### **ADDENDUM NO. 3**

Date: **03/23/23**

Issued by: **Sacramento City Unified School District**

Project: **Project #0168-418 John D. Sloat ES Paving, Playground, and Fencing Project**

**A1 FENCE POST @ LANDSCAPE**  
 1" = 1'-0"

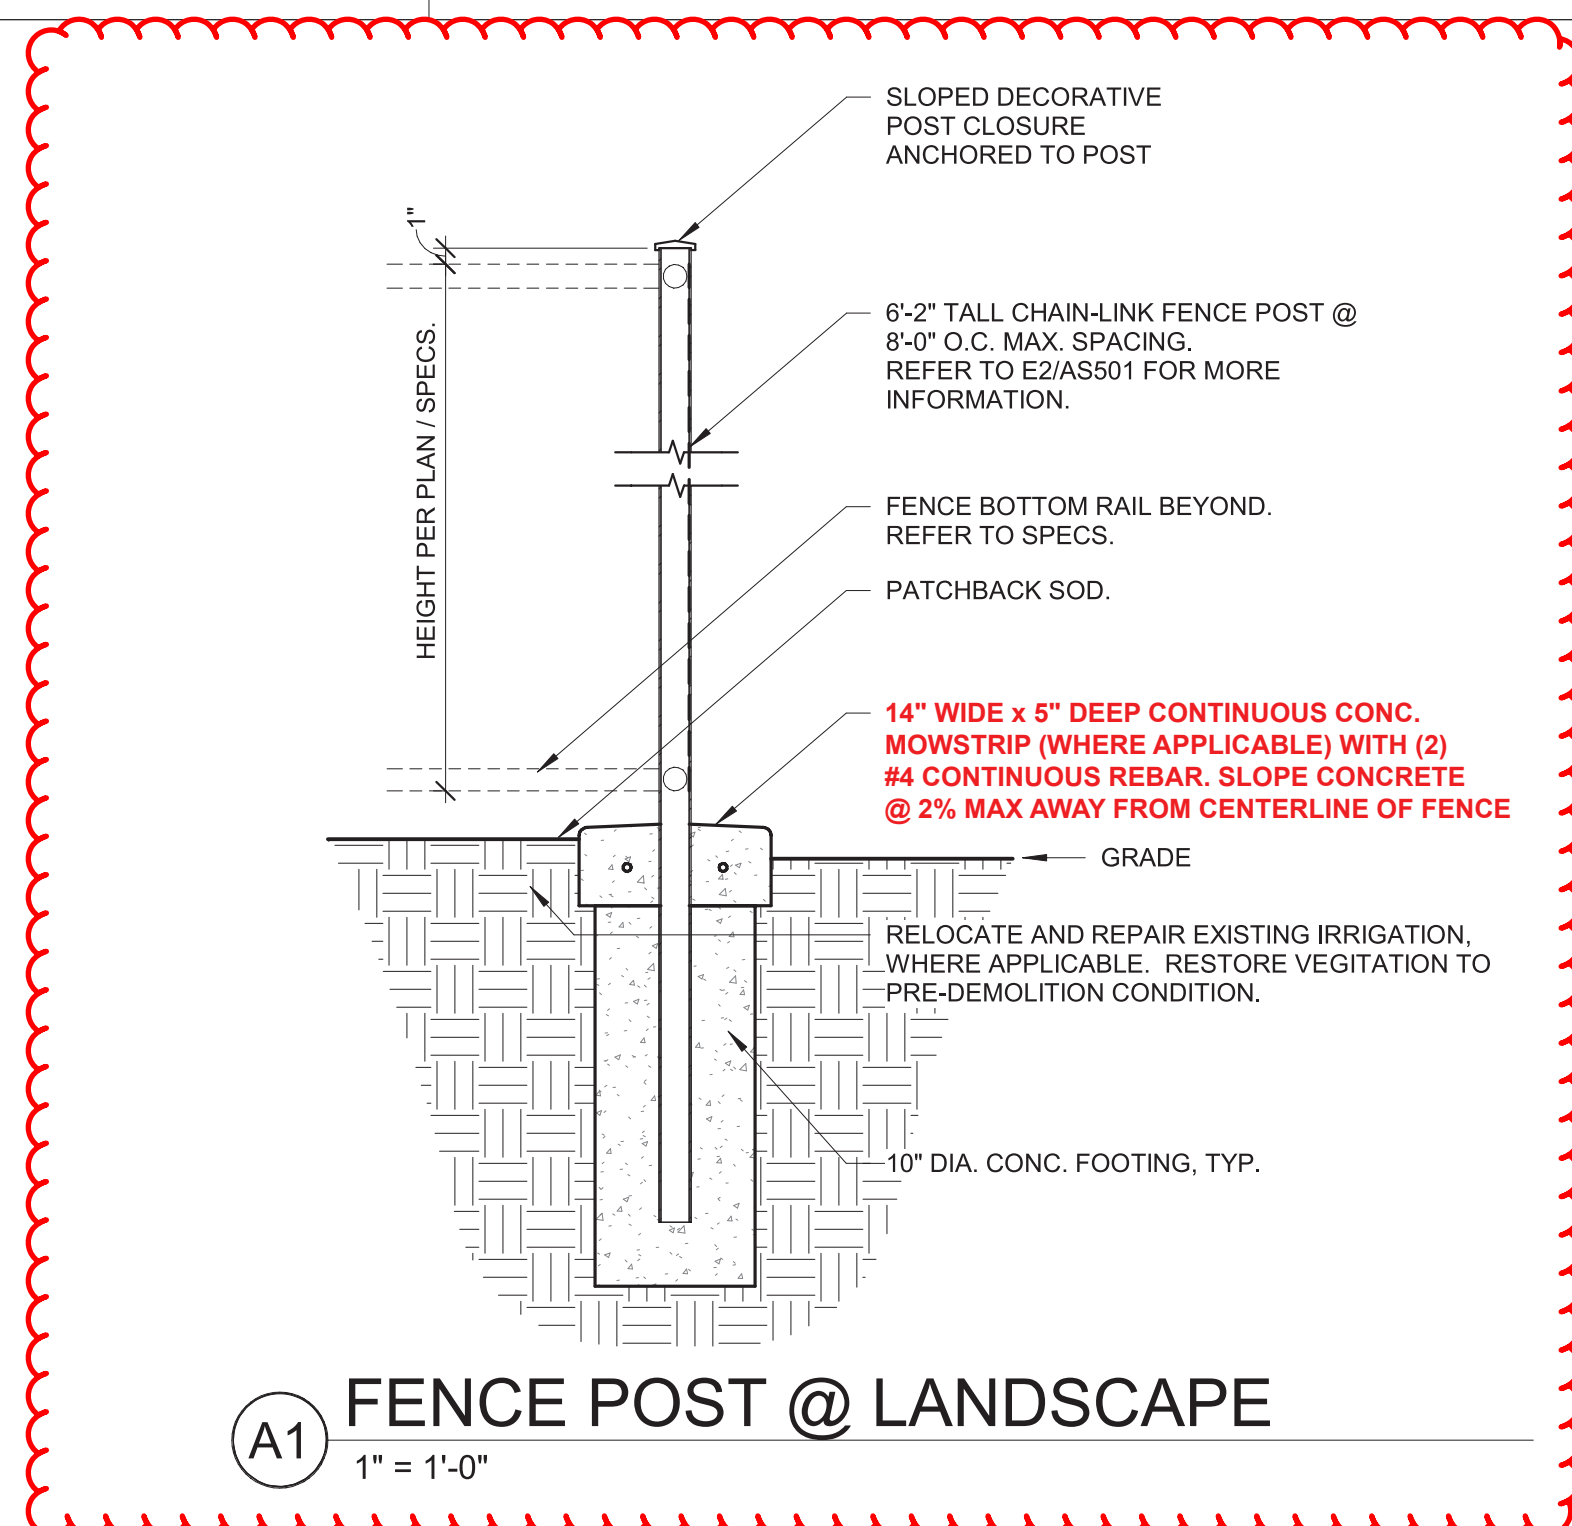
- AD03.10 Sheet AS501 – Site Details, Detail A1 – Fence Post @ Landscape: Refer to the attached **ADD3 AS103, Detail A1 – Fence Post @ Landscape**. All changes are clouded in red.

- A2: **Refer to response in Addendum # 3, above.**
- Q3: Mow strip under the perimeter fence is called out to be 12" on detail A1 of sheet AS501 vs but the note 6.51 on sheet AS100 indicates the mow band under the fence to be 14". Please confirm the mow band size under the fence.
